NOTICE TO APPLICANTS ADDENDUM NO. FOUR (4)

Big Lagoon State Park – Boat Ramp Area Improvements DEP BID NO. BDC25-18/19

- Revised Civil Sheet 106
- Revised Structural Sheets S201-S203

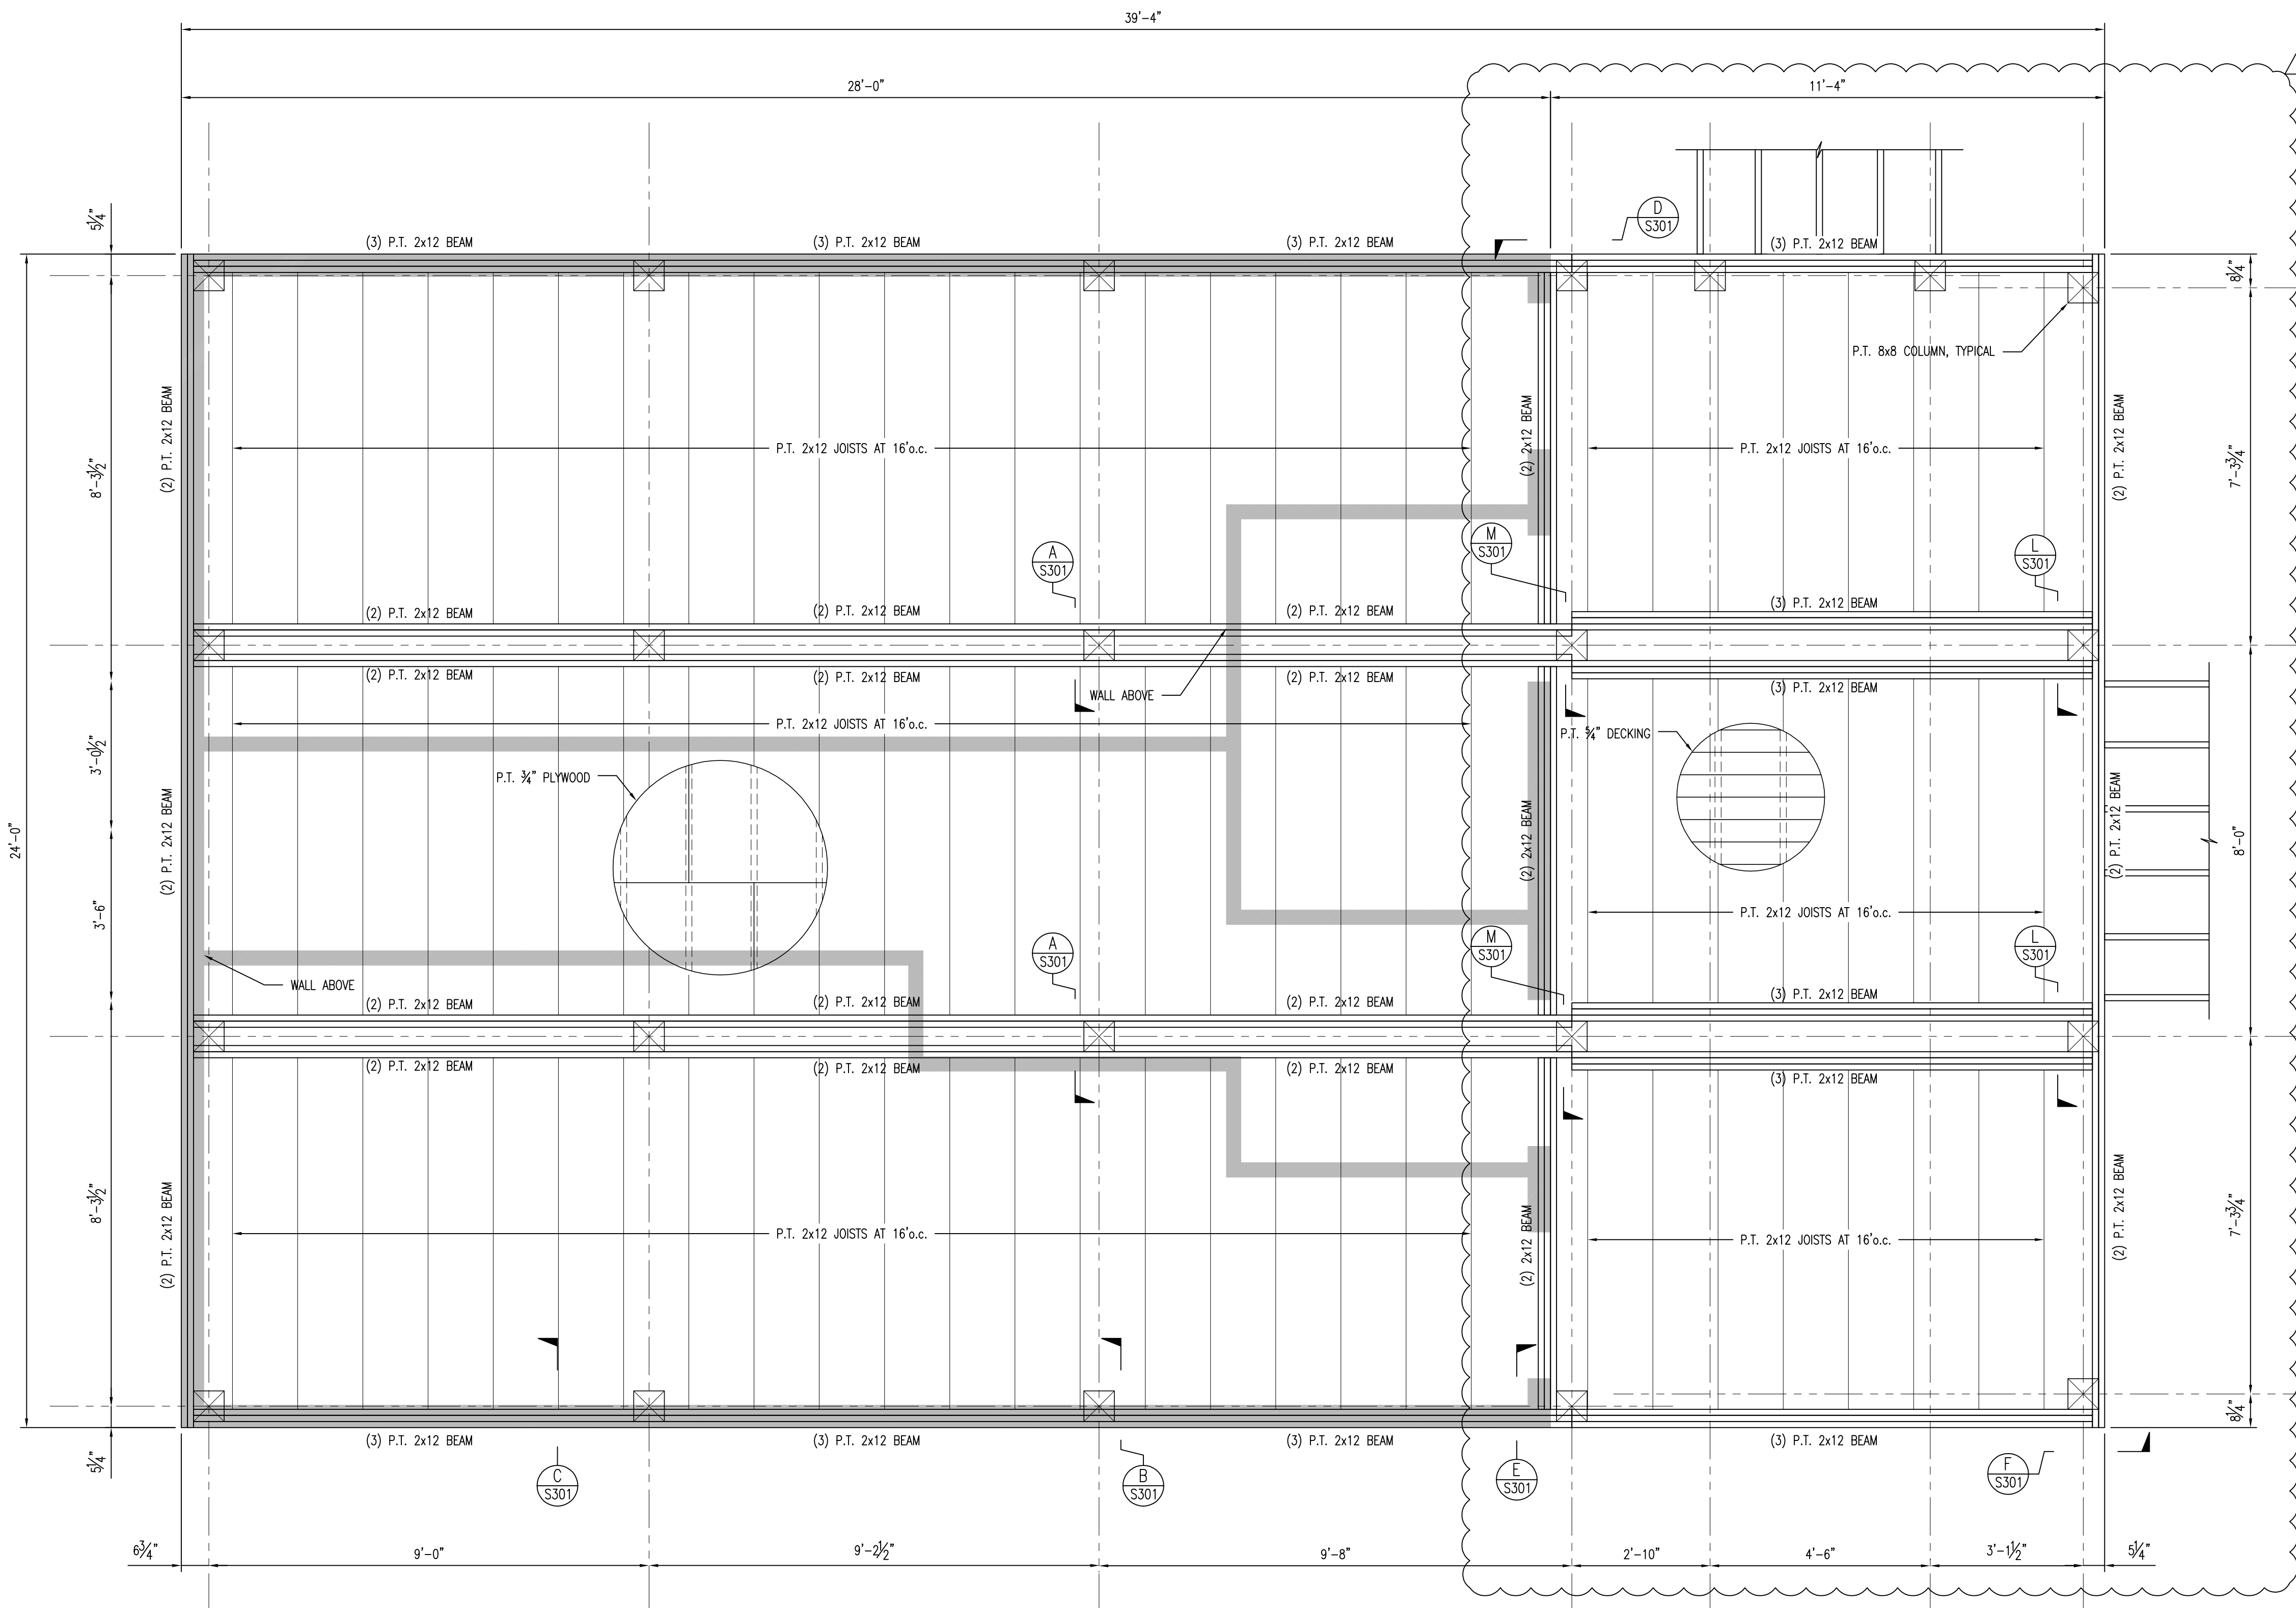
- 8. Question:** The Plans indicate Alternates for other work: Relocate 486 LF of 6” water line
Answer: This is not a bid alternate.
- 9. Question:** The Plans indicate Alternates for other work: Concrete Pavement north of the trench drain
Answer: Sheet C106 has been revised – bid alternate for concrete north of trench drain has been deleted. This will be asphalt.

SHEET NO.	S201
-----------	------

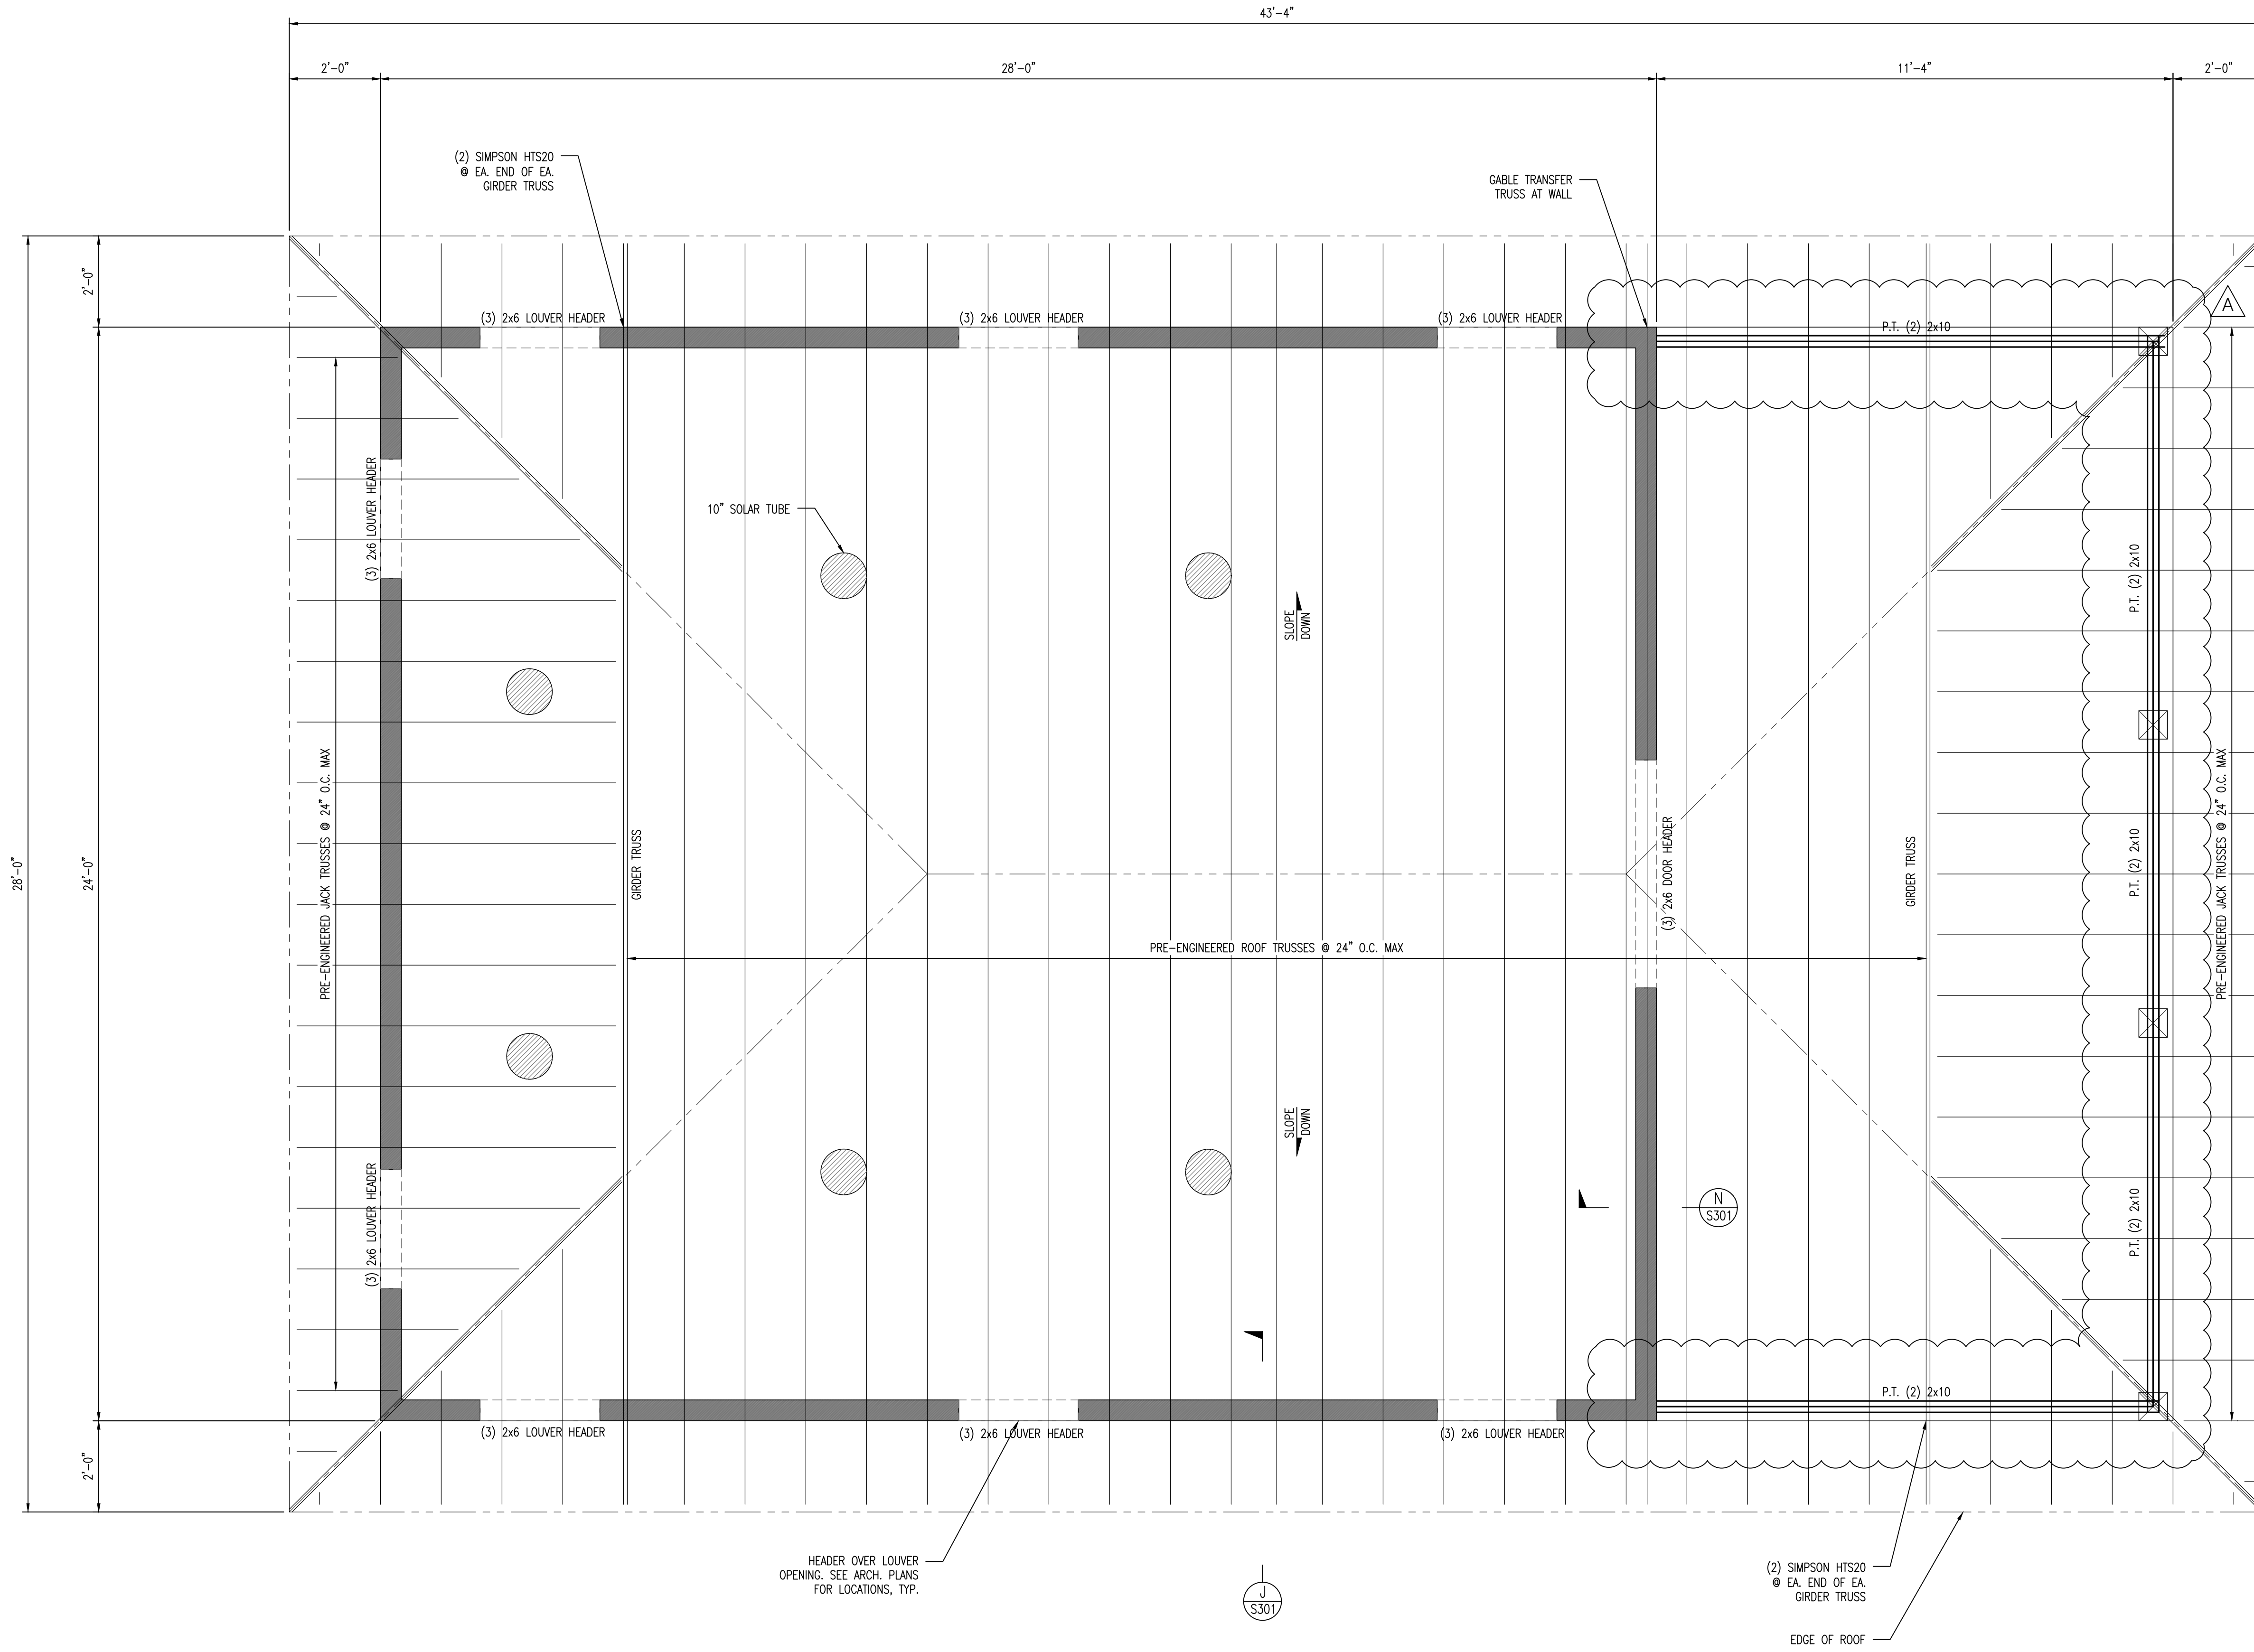
- 7. Question:** Concerning the porch framing on sheet S201. The outer most pilings, plan right, are 8x8's (see L/S301, but at the floor level they change to 6x6's. How is the base of the 6x6's connected? I see no detail. Note: the 6x6's are shown on multiple pages so I feel the 6x6's are wanted although it would appear to be a stronger wind connection if the 8x8's went to the roof system.

Answer: The drawings have been revised to show an 8x8 above finished floor. These changes will be seen in the attached sheet.
